Duke Power Company
Oconee Nuclear Station

Proposed Technical Specification Revision
Oconee 1 Cycle 10

<u>Remove Pages</u>	<u>Insert Pages</u>
vi	vi
vii	vii
viii	viii
2.1-1 thru 2.1-12	2.1-1 thru 2.1-5
2.3-1 thru 2.3-13	2.3-1 thru 2.3-7
3.1-8	3.1-8
3.1-19a	3.1-9a
3.1-20	3.1-20
3.1-23	3.1-23
3.5-2	3.5-2
3.5-4 thru 3.5-5	3.5-4 thru 3.5-5
3.5-5c thru 3.5-12	3.5-5c thru 3.5-12
3.5-15 thru 3.5-29	3.5-15 thru 3.5-28
6.6-1 thru 6.6-4	6.6-1 thru 6.6-4
ix	ix

Figure 2.1-1
OCONEE NUCLEAR STATION

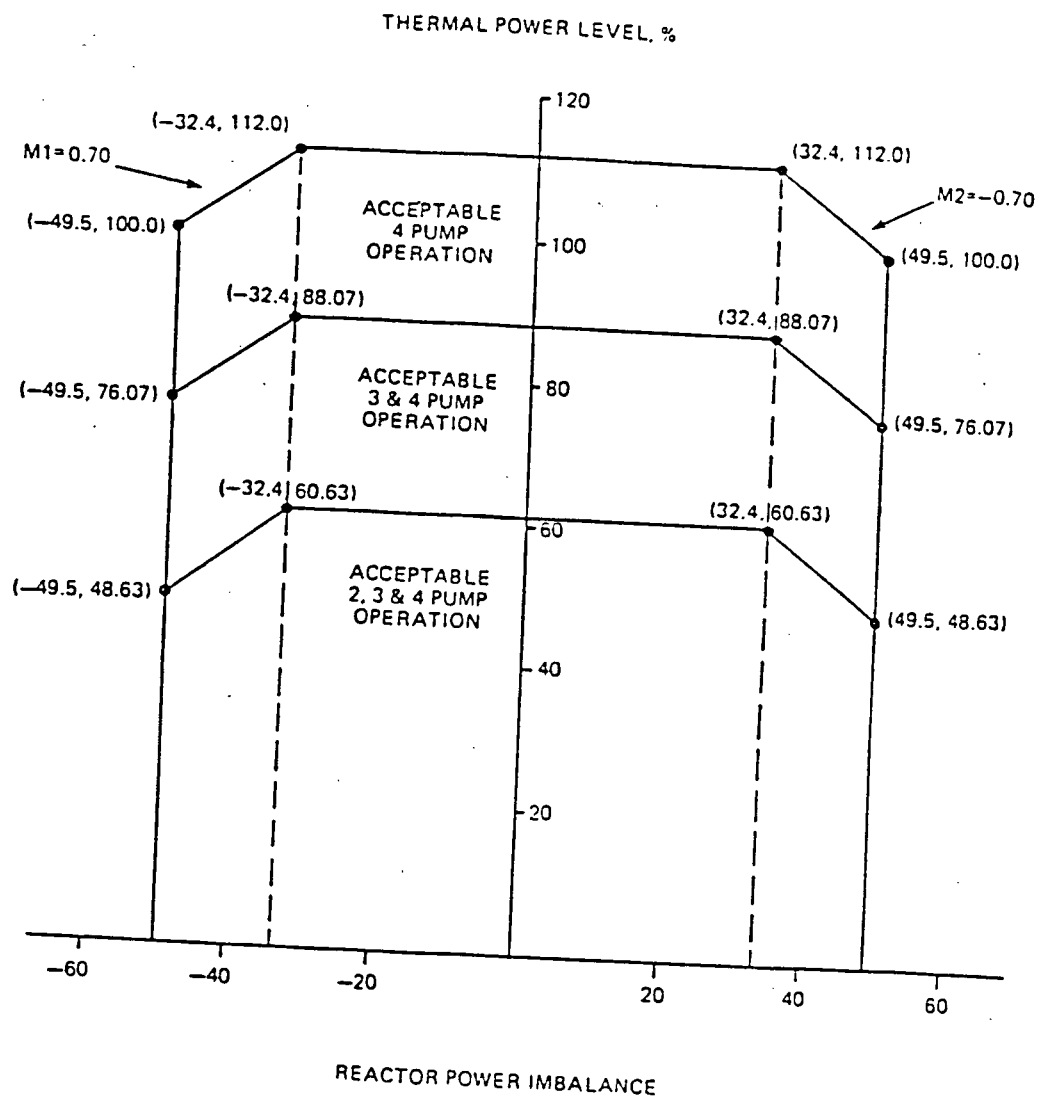
The combination of the reactor system pressure and coolant temperature shall not exceed the safety limit as defined by the locus of points established in Figure 2.1-1. If the actual pressure/temperature point is below and to the right of the line, the safety limit is exceeded.

The curve presented in Figure 2.1-1⁽³⁾ represents the conditions at which the minimum allowable DNBR is predicted to occur for the limiting combination of thermal power and number of operating reactor coolant pumps. This curve is based upon the design nuclear peaking factors which include the potential effects of fuel densification⁽⁴⁾:

Figure 2.3-1
OCONEE NUCLEAR STATION

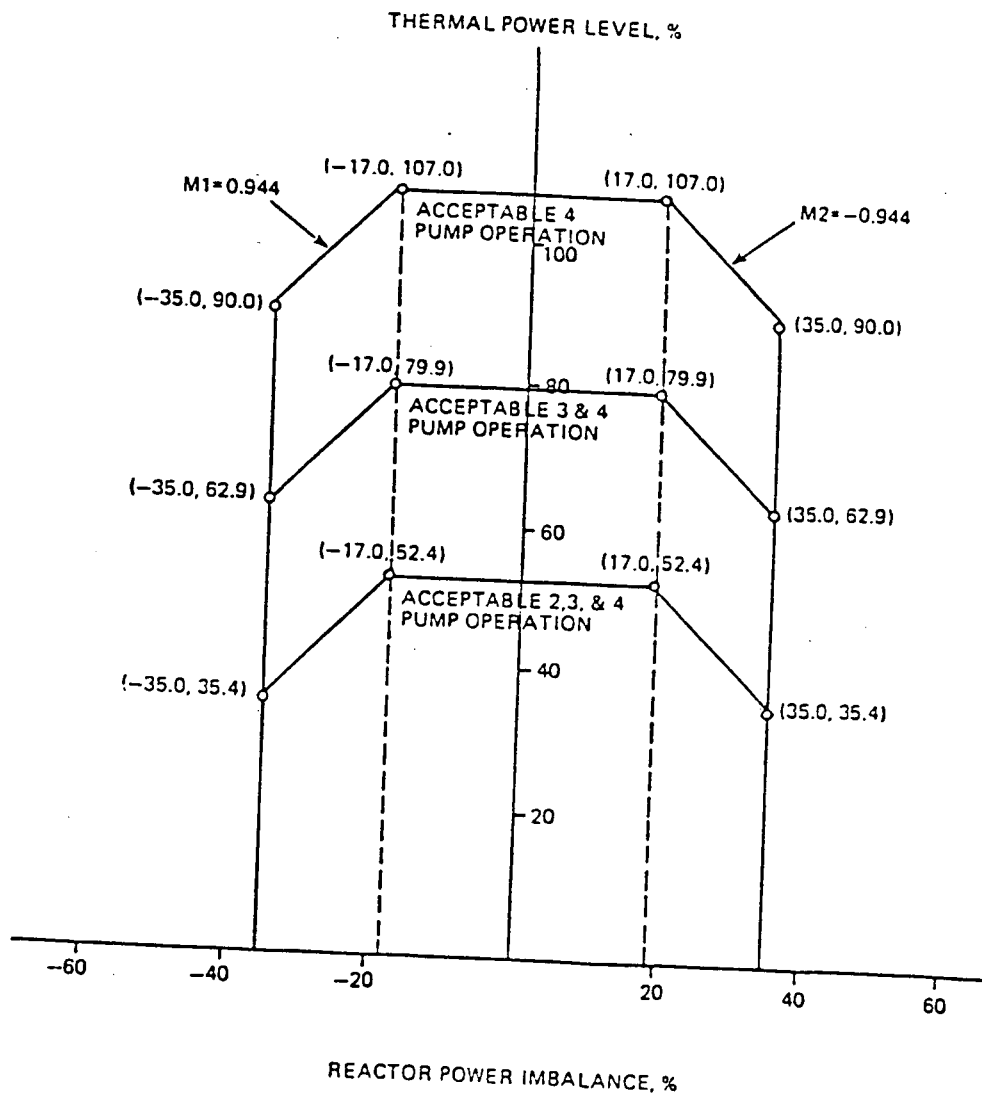
The high reactor coolant outlet temperature trip setpoint (618°F) shown in Figure 2.3-1 has been established to prevent excessive core coolant temperatures. Accounting for calibration and instrumentation errors, the safety analyses used a trip setpoint of 620°F.
